REMARKS

APPLICATION NO. 10/637,929
AMENDMENT DATED NOV 21, 2005
REPLY TO OFFICE ACTION OF AUG 23, 2005
ANNOTATED SHEET SHOWING CHANGES

FIG. 2

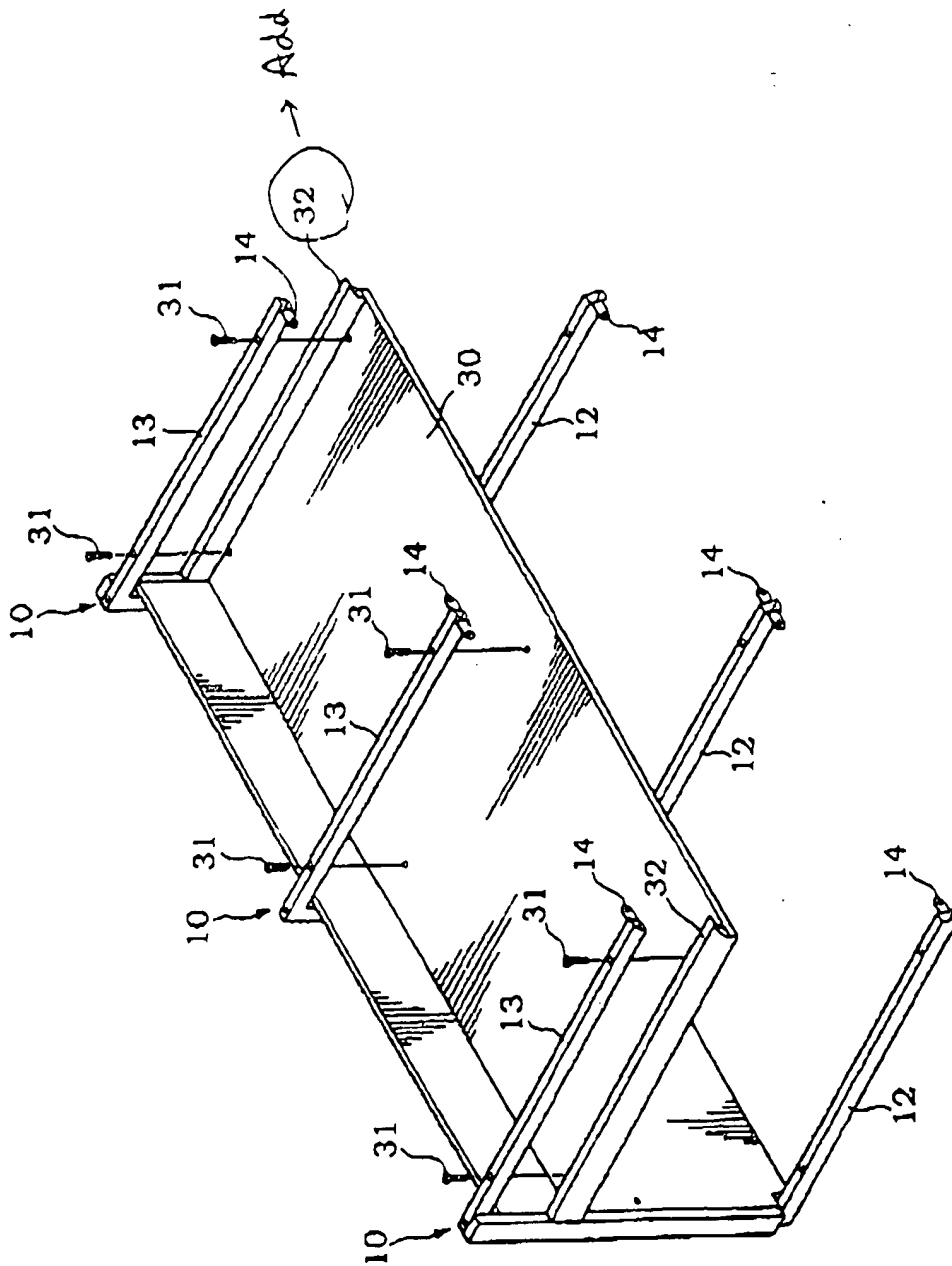
The attached sheet of drawings includes changes to Fig. 2. This sheet which includes Fig. 2 replaces the original sheet including Fig. 2. In Fig. 2 previously omitted references numeral 32 has been added.
